Access Compliance Report

Public Rights-of-Way

Intersection ID: N/A	Main Street: SOUTHSTREAM_BV	Cross Street: N/A	Location: S
ADA ID: B6D2FC79EDA2	Ramp Type: PerpDiag	Initial Pass/Fail: Fail	Overall Compliance: No
Codes/Mitigation Info/Possible Solution		Field Measurements/Component Compliance	
Severity Score: 13.75

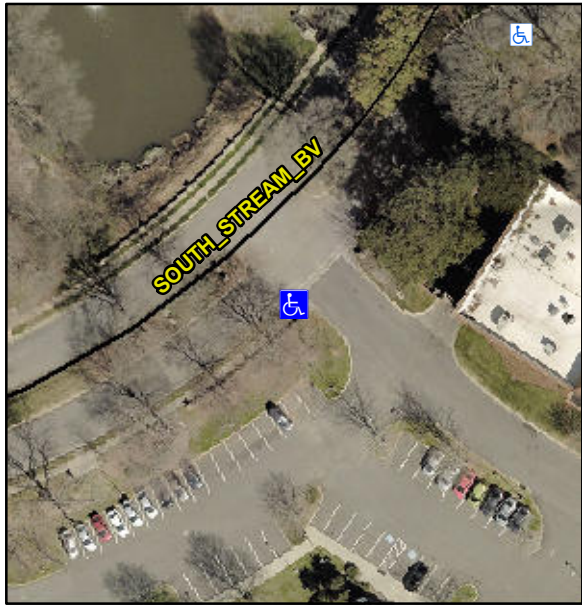
Possible Solutions:		Compliance		Description	Data	Compliance		Description	Data
	Remove & Replace Curb Ramp With Two New Directional Ramps or Equivalent.		N/A	Ramp Length (in)	51.0	No	Ramp Slope (%)	9.1		
			Yes	Ramp Width (in)	48.0	No	Ramp XSlope (%)	2.3		
			N/A	Flare Type LT	N/A	N/A	Flare Type RT	N/A		
			N/A	Flare Slope LT (%)	N/A	N/A	Flare Slope RT (%)	N/A		
			N/A	Flare Traversable LT?	No	N/A	Flare Traversable RT?	No		
			N/A	Landing Length (in)	N/A	N/A	DWS Provided?	N/A		
			N/A	Landing Width (in)	N/A	N/A	DWS Contrast?	N/A		
			N/A	Landing Slope (%)	N/A	N/A	DWS Length (in)	N/A		
			N/A	Landing X Slope (%)	N/A	N/A	DWS Full Width?	N/A		
Surveyor Notes:		N/A	N/A	Landing Curb? (Y/N)	N/A	N/A	DWS Offset (in)	N/A		
		N/A	Shared Landing?	N/A						
		N/A	Gutter Ponding?	N/A	N/A	Gutter Slope (%)	N/A			
		N/A	Gutter Lip Ht (in)	N/A	N/A	Gutter X Slope (%)	N/A			
		N/A	Painted X Walk1?	No	N/A	Painted X Walk2?	No

X Walk 1 Direction	To NE		X Walk 2 Direction	To NW			
		N/A	X Walk 1 Width (in)	N/A	N/A	X Walk 2 Width (in)	N/A			
			X Walk 1 Slope (%)	0.5		X Walk 2 Slope (%)	4.8			
			X Walk 1 X Slope (%)	3.3		X Walk 2 X Slope (%)	0.1			
		N/A	Ramp inside XWalk1?	N/A	N/A	Ramp inside XWalk2?	N/A			
			Road Slope (%)	1.3	N/A	Clear Space?	N/A			
			Road X Slope (%)	1.7	N/A	Clear Space to XWalk (in)	N/A			
		N/A	Any Obstructions?	N/A	N/A	Storm Grate/Utility Hazard?	N/A			
			Obstruction Type			Storm Grate/Utility Type				
					N/A		N/A			
					Yes	Surface Condition? (G/P)	Good
